UNITED STATES PATENT AND TRADEMARK OFFICE

10/554,654

Office Action Summary	Application No.	Applicant(s)	
	10/554,654	MORTOR ET AL.	
	Examiner	Art Unit	
	Courtney Thomas	2882

DETAILED ACTION

Fig. 1 (& magnified view) – X-ray tube- U.S. Patent 5,987,097 to Salasoo

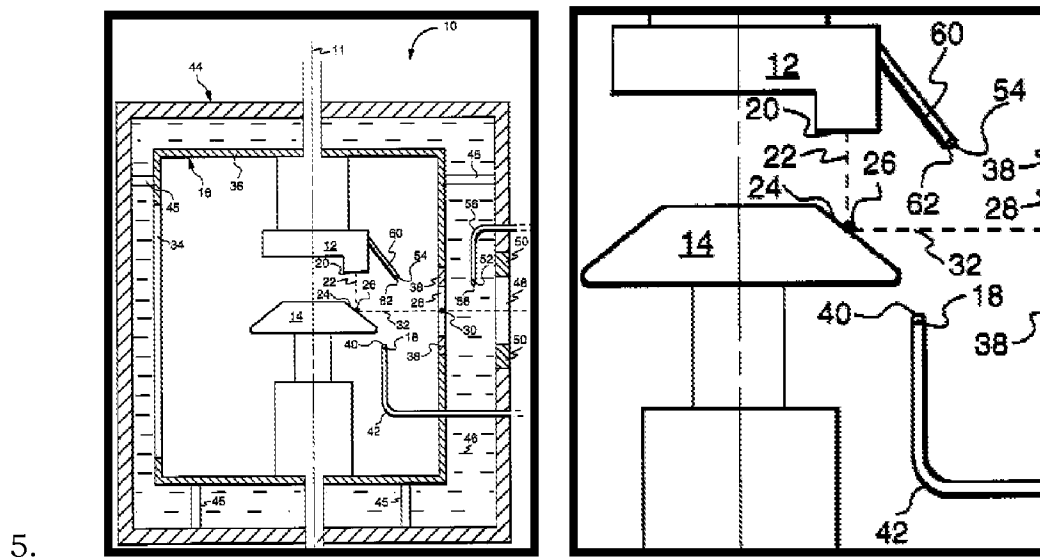
6. **As per claim 1**, Salasoo discloses an X-ray tube comprising: a cathode (12); an anode (14) and a retardation electrode (18) held at a negative potential with respect to the anode (col. 3:30-36) to produce an electric field between the anode (14) and retardation electrode (18); wherein retardation electrode (18) is located on an opposite side of the anode (14) to the cathode (12). [Examiner note: electrodes 54 and 58 are also taught to assist in the reduction of heat within the tube.]

7. **As per claim 2**, Salasoo discloses an X-ray tube wherein the retardation electrode (18) is held at a positive potential with respect to the cathode (12) – (col. 3:40-43).

8. **As per claims 3-4**, Salasoo discloses an X-ray tube wherein the retardation electrode (18) forms part of an electrical circuit and its potential is substantially constant (col. 3:30-47).

9. **As per claims 6-7**, Salasoo discloses an X-ray tube further comprising a housing (44, 16) enclosing the cathode (12) and anode (14), wherein at least part of the housing (44, 16) forms the retardation electrode (18, 58); and wherein the retardation electrode (18, 58) is located between the anode and the housing.

10. **As per claims 10-11**, Salasoo discloses an X-ray tube wherein the tube further defines a window through which X-rays are emitted (48) and wherein the retardation electrode (18, 58) extends between the anode (14) and the window (48).
